■BODY

Low Vibration and Low Noise Body

047BO04Y

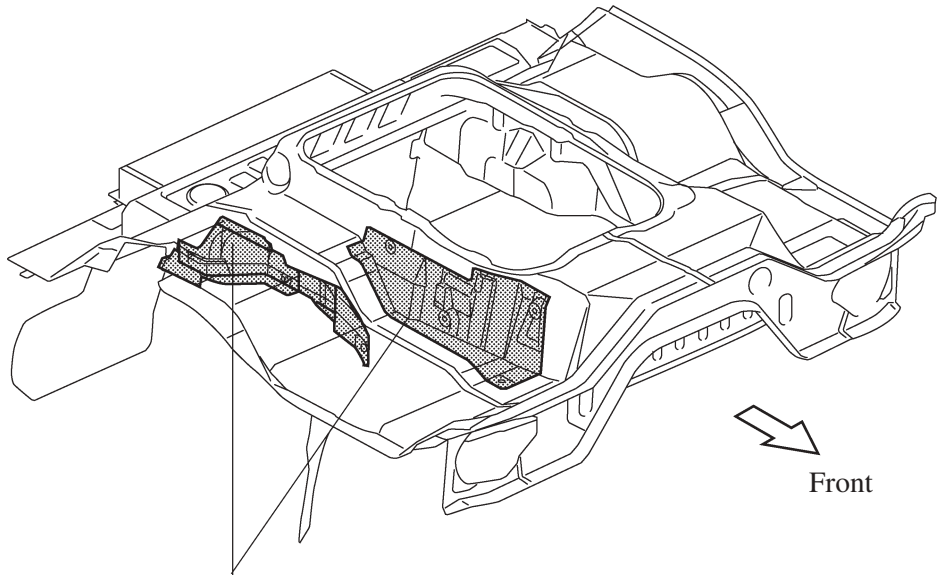
- Sound insulation panels have been added for the rear floor board of the N04C-TQ engine models except for the Europe models.

- Along with the provision of the N04C-TQ engine, asphalt sheets are applied the front floor area to reduce noise and vibration only for the Hong Kong and Singapore model.

- The thickness of the engine room silencer has been changed from 5 mm (0.2 in.) to 20mm (0.8 in.) on the N04C-TQ engine models.
